DATE: December 11, 2019

SUBJECT: ADDENDUM #3 TO THE BIDDING DOCUMENTS FOR:  
**BID GROUP #8**  
**MASTER FACILITY PLAN IMPLEMENTATION**  
**COMMUNITY HIGH SCHOOL DISTRICT 99**  
**1436 NORFOLK STREET**  
**DOWNERS GROVE, IL 60516**

This addendum forms a part of the Bidding Contract Documents, dated November 20, 2019. Bidders must acknowledge receipt of this Addendum in the space provided on the Bid Form. Drawing revisions clouded and tagged throughout with delta 39.

**10** DETAIL - SIDE WALL ACOUSTIC CURTAIN (TYP.)  
SCALE: 3/4" = 1'-0"

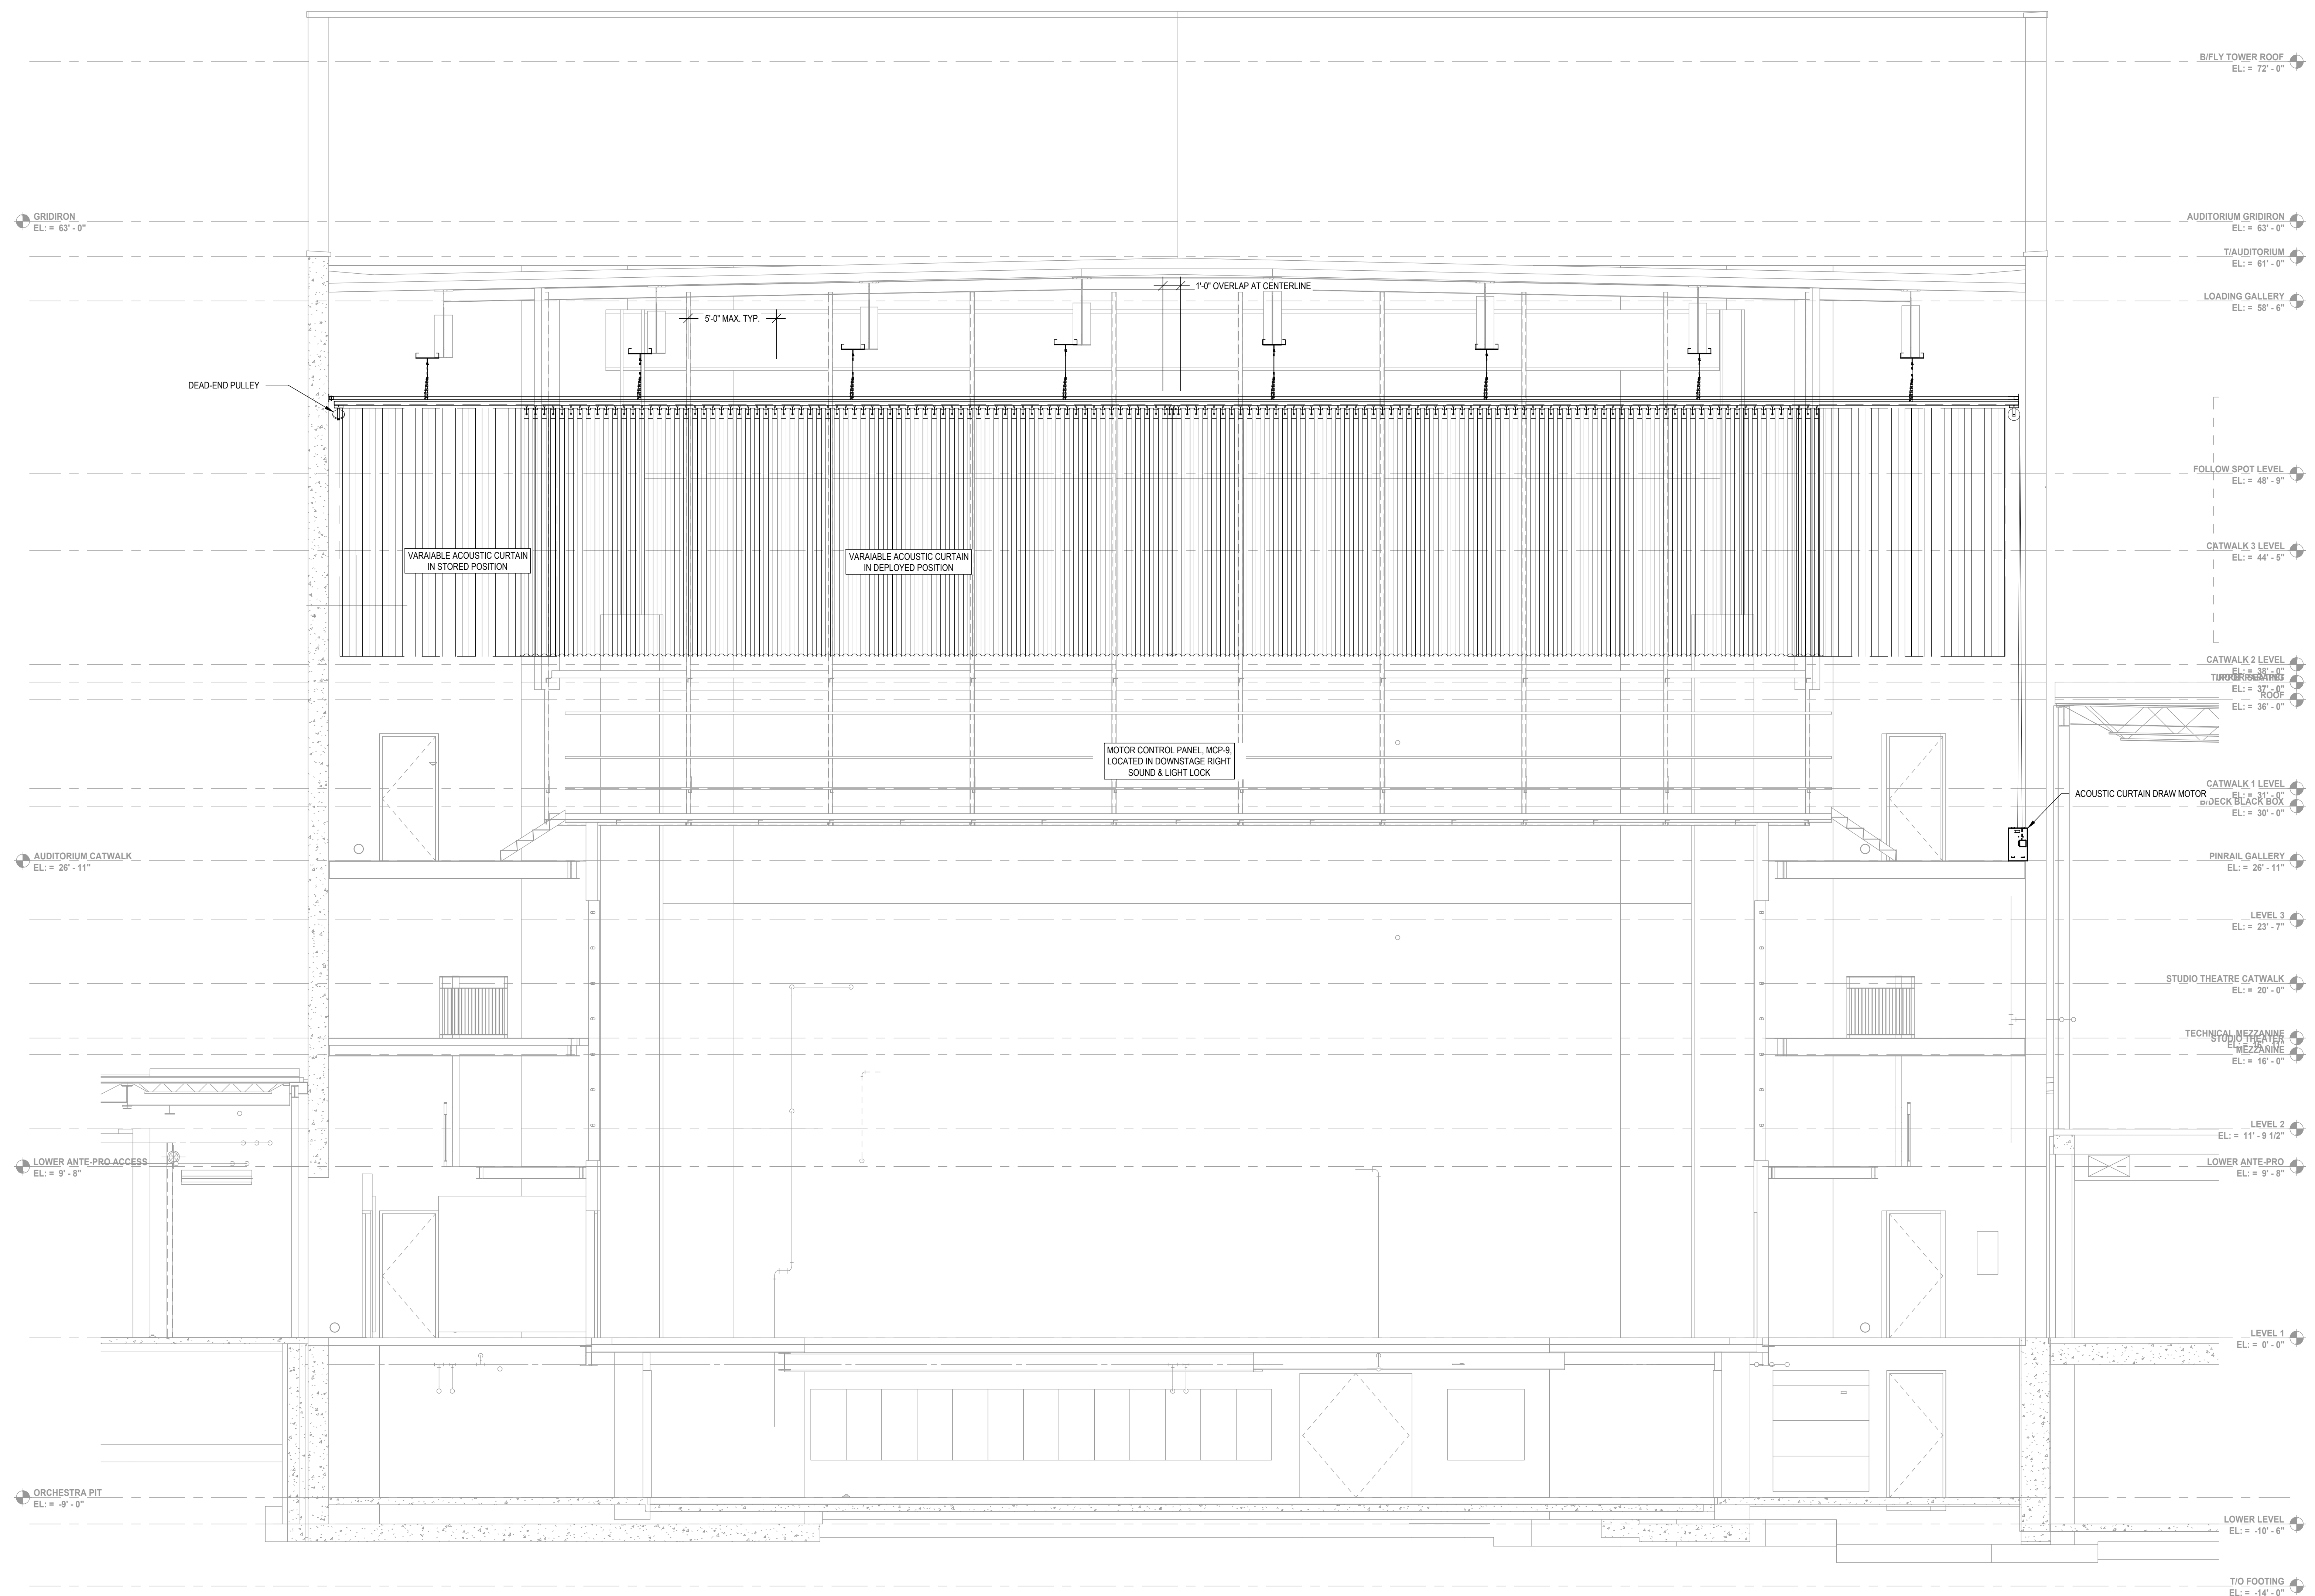
- a. Relocation of Proscenium Wall Acoustic Curtain.
  - b. Updated detail for side wall acoustic curtain
- 7. Sheet TR5.12 THEATRE RIGGING PROSCENIUM THEATRE DETAILS **(Full size sheet issued)**

# EA2.10F

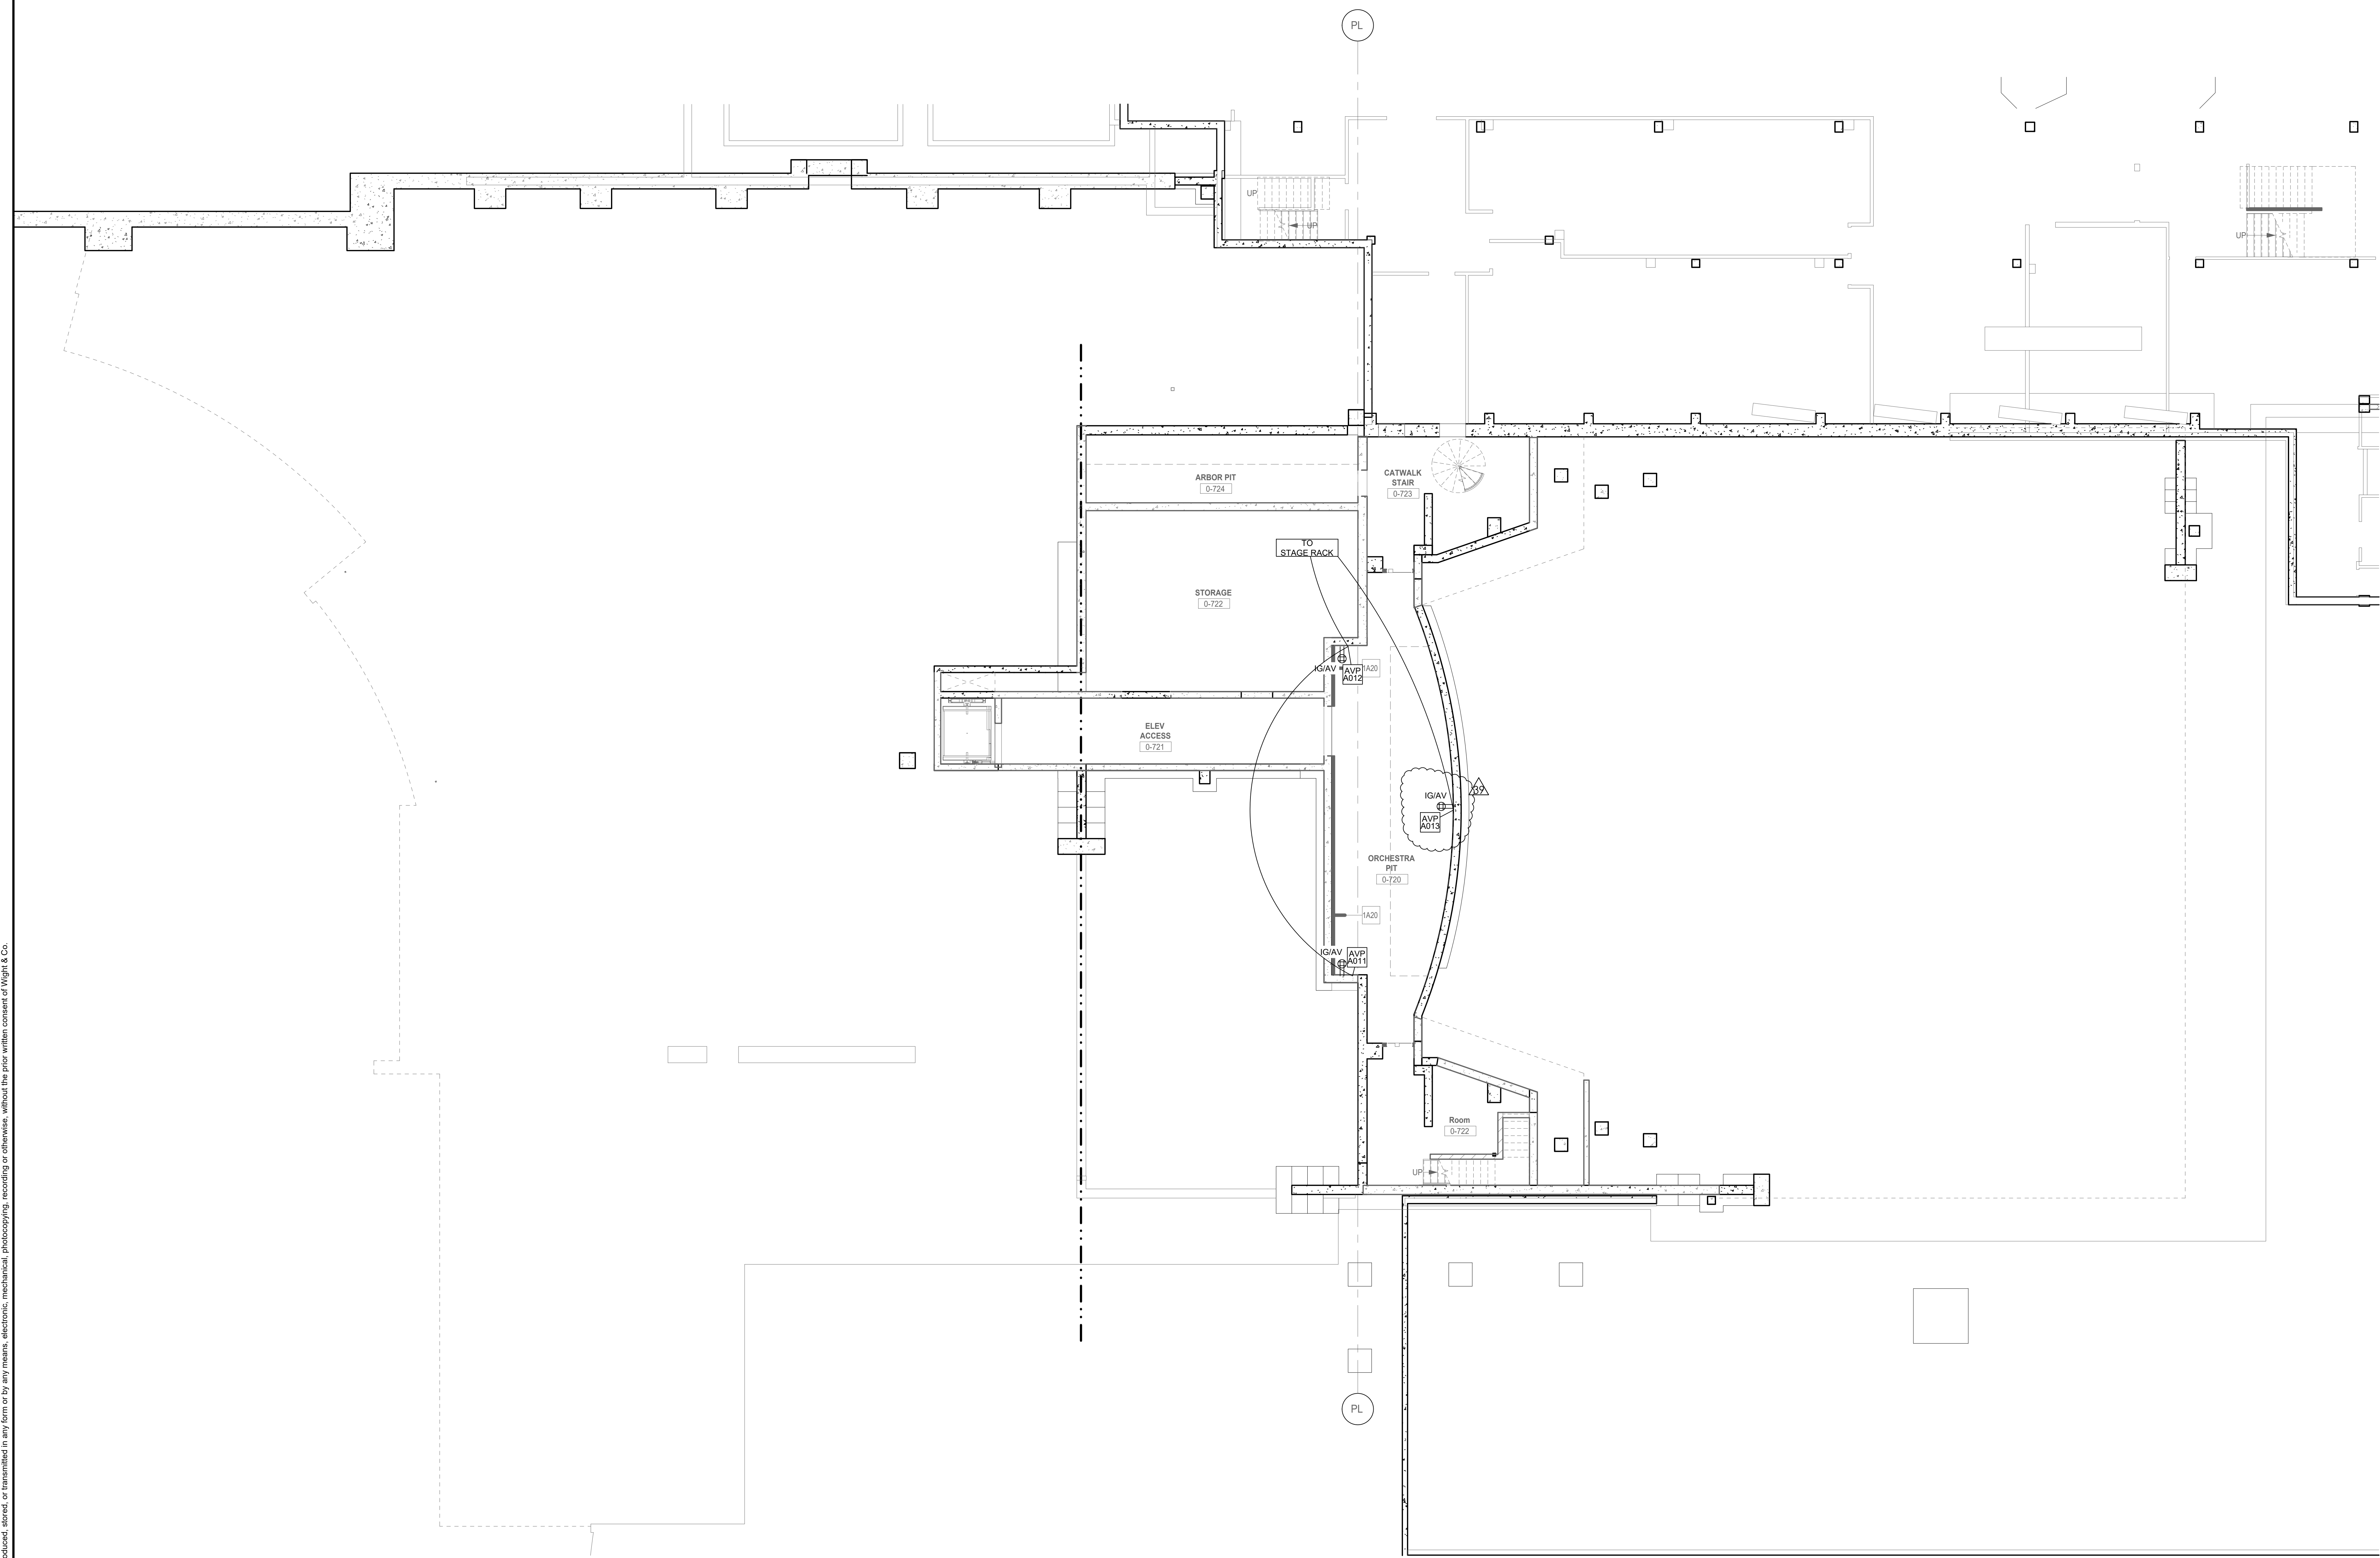
- 1. Sheet EA2.10F ELECTRICAL FOR AV SYSTEMS - ORCHESTRA PIT LOCATIONS **(Full size sheet issued)**
  - a. Add panel AV013 and update conduit.
